Flight Procedures Cover Page	Task Action: FLIGHT CHECK	Task Type: SID			APWS Project ID: F5B23552404D469585C38455E9A42BEE		
Procedure: Enroute: YES			Specialist: Palmer, Leo		Agreement Number:		
Airport ID: KLUD			Airport City: DECATUR	State: TX			
Facility ID:	Facility Type:	Flight Inspection Remai New FC Slot	rk Type:

ORIGINAL PROCEDURE. - REPLACES SWABR ONE (RNAV). - CHANGING IF FIX FROM BOTCH TO DEMII

## BOTCH ONE DEPARTURE (RNAV)

BOTCH ONE DEPARTURE (RNAV)
(BOTCH1.BOTCH) FIG

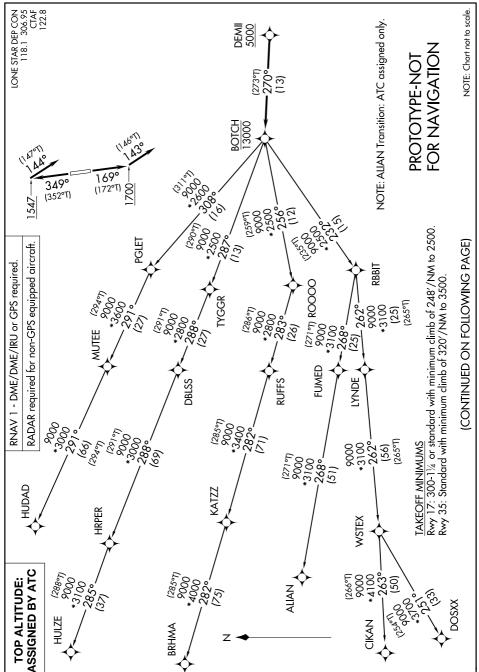
1. DOSXX TRANSITION MEA FROM BOTCH TO RBBIT MEA CHANGED FROM 8000 TO 9000.
